DESIGNED BY: M. VESLENO	DATE: 11/29/2016
REVIEWED BY:	
REFERENCE PLANS N/A	
SHEET 1 OF 1	SERIAL NO. N/A

PROJECT:	CURB RAMP DESIGN INTERSECTION @ ROXFORD ST & HERRICK AVE
ADDRESS:	INTERSECTION @ ROXFORD ST & HERRICK AVE

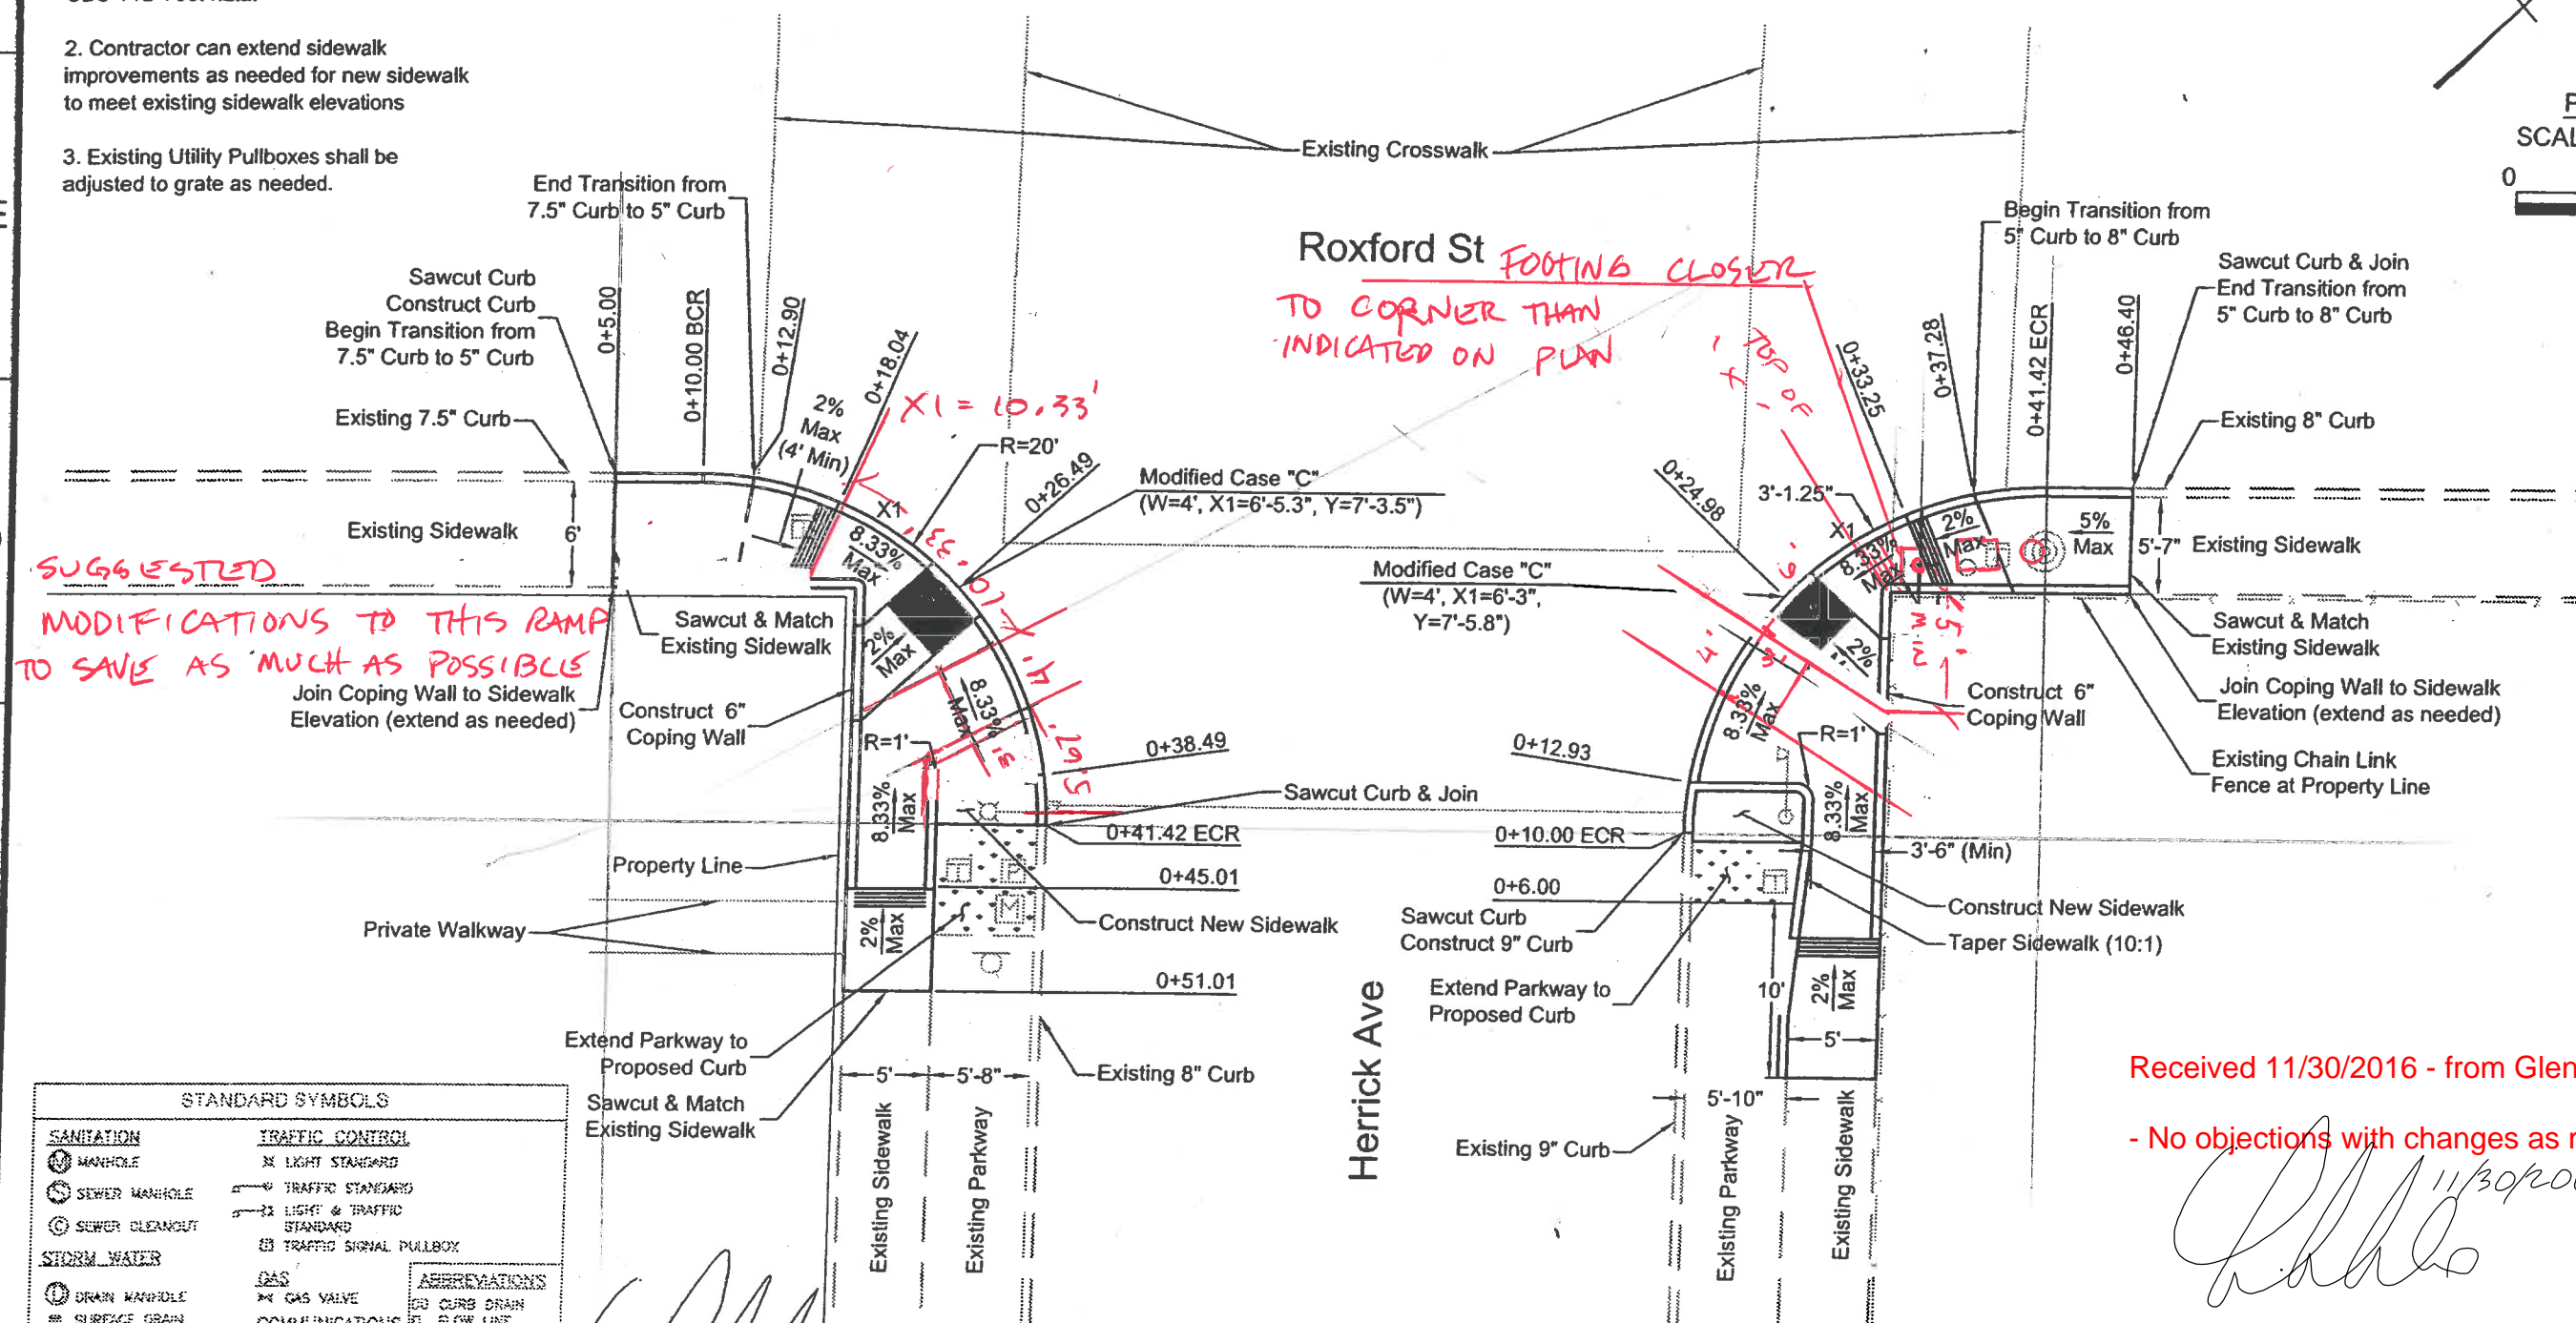
**SUGGESTED
MODIFICATIONS TO THIS RAMP
TO SAVE AS MUCH AS POSSIBLE**
Join Coping Wall to Sidewalk
Elevation (extend as needed)

Received 11/30/2016 - from Glenn Hoke (BSS)
- No objections with changes as marked.
